## 5 CHAPTER 5: CHANGES TO THE PROPOSED DEVELOPMENT

### 5.1 Introduction

The submitted scheme for the Proposed Development was defined in the ES Volume 1 Chapter 5: Project Description, and this Chapter of the ESA provides an update describing the changes that have been made to the Proposed Development to address the issues raised during consultation. It should be assumed that any details of the scheme not described in this Chapter have not been changed since the submission of the ES, and therefore Volume 1, Chapter 5 of the ES should be referred to and read in conjunction with this Chapter.

**Image 5.1: Example micro-phases**

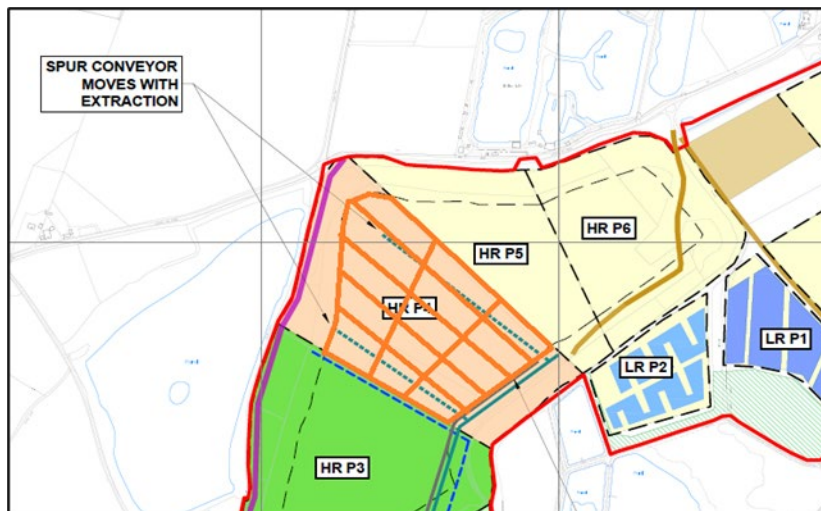
The Amended Proposed Development would adopt the principle of micro-phasing, whereby each of the larger extraction phases (HR P1-P6 and LR P1-P5) would be split into small 'micro-phases'. The example in Image 5.1 shows HR P4 split into micro-phases.

Each phase would be split into micro-phases, as shown in the example in Image 5.1 above. These would be topsoil stripped individually, followed progressively by the PFA extraction process, so only one micro-phase would be worked on at a time. The soil stripping would take place progressively by micro-phase, with no need to strip and uncover the entire phase, thereby limiting exposed areas and the associated potential dust, noise and visual impacts.

**Image 5.3: Illustrative section to demonstrate working in the High-Rise**

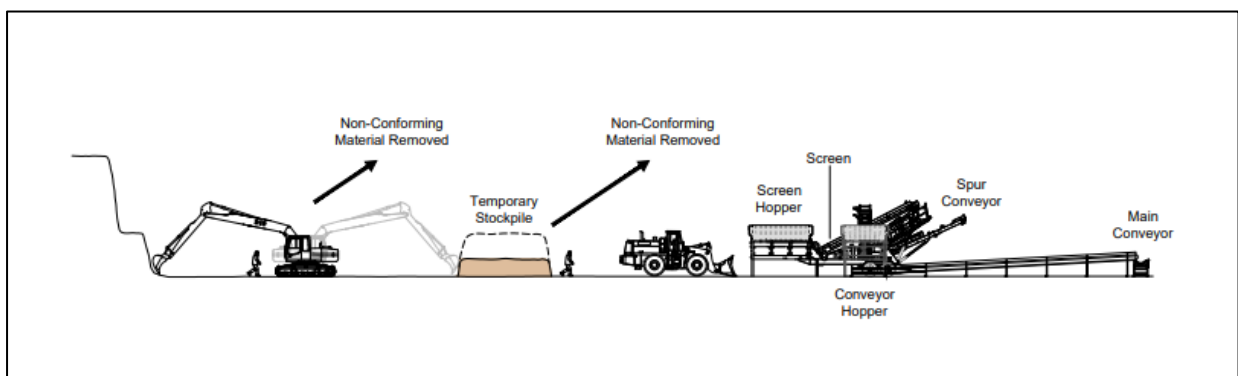
- Following extraction of the PFA, HR P1 would be restored using material available from the lagoon embankments to achieve the required restoration levels. Importantly, the sandstone embankments would only be removed once the extraction phase is complete and the restoration phase begins, enabling them to continually screen the extraction area as works are ongoing. The illustrative section in Image 5.3 demonstrates the process.

**Image 5.5: Indicative 'dig down' area locations**

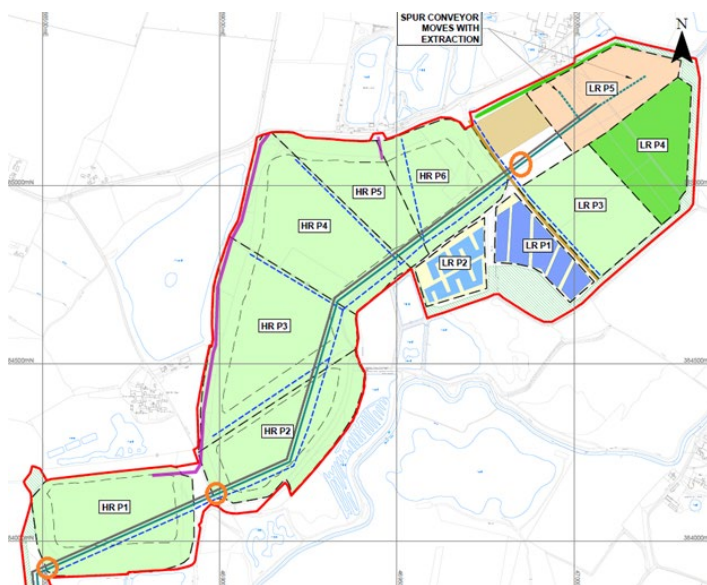
A major embedded mitigation proposal within the Amended Proposed Development is to ensure the maintenance / haul road remains at a lower level within the extraction void in order to fully benefit from the screening provided by the existing lagoon embankments and the extraction face in terms of potential noise, dust, and visual impacts. To reach the desired lower level (approximately 5 m within the High-Rise and approximately 2 m within the Low-Rise), 'dig down' works need to take place, where cuts are dug to establish the below surface level extraction base.

These works are limited to three areas within the Site, as shown on Image 5.5, and would be short-term and temporary. 'Digging down' in the southwestern corner of HR P1 (the proposed starting phase) to begin extraction would occur during site establishment, and would be completed after a maximum of approximately 10 days. 'Dig down' would then also need to occur at the southwestern corner of HR P2, and to the south west of LR P5, to allow the progressive extension of the maintenance / haul road and conveyor. The initial 'dig down' cut would be approximately 15 m wide, and from there extraction would take place at the lower level, following the simultaneous extension of the maintenance / haul road and conveyor through Area A from west to east.

**Image 5.6: Proposed location for additional acoustic/visual mitigation**

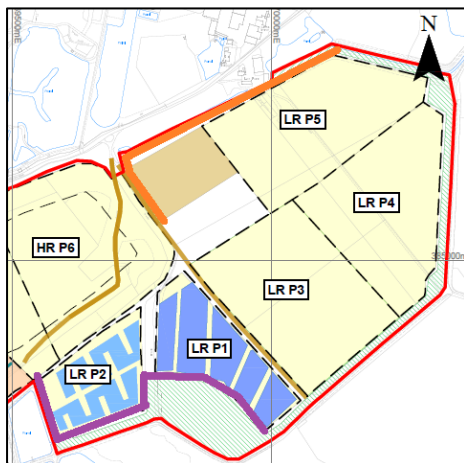
- It is therefore proposed to provide temporary 2-3 m high acoustic fencing and/or a temporary seeded earth bund along the northern and southern boundaries of the Low-Rise close to sensitive receptors. The proposed locations are denoted by the orange and purple lines as shown in Image 5.6.

- This additional mitigation, forming a new part of the Amended Proposed Development, would remain for the duration of the extraction process in the Low-Rise and would effectively provide a combined height of up to approximately 5 m of screening for sensitive receptors (comprising the minimum 2 m extraction base and up to 3 m of fencing/bund).

Image 5.7: Section of SSSI embankment to be retained

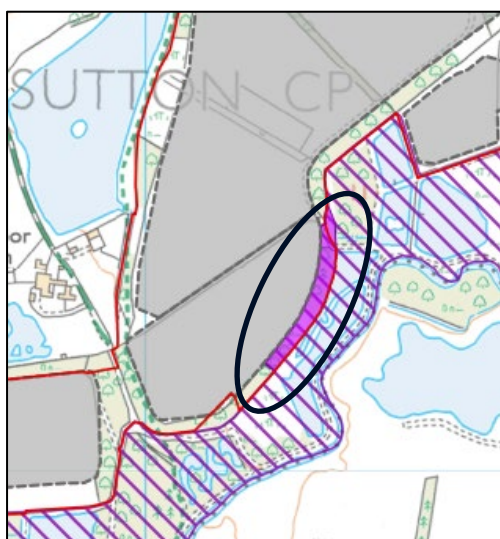
The Restoration Plan has now been amended (Figure 7.12 – 7.14 in ESA Volume 2, and Technical Appendix 5.4 in ESA Volume 3) to retain the small section of SSSI as highlighted on the plan extract below (Image 5.7). Previously it was proposed to partially remove this embankment (lowering of the lagoon embankment) to facilitate restoration proposals as part of the Proposed Development described in the ES, and to replace it with improved habitats. With the Amended Proposed Development, the embankment would be retained to mitigate potential impacts to the SSSI.
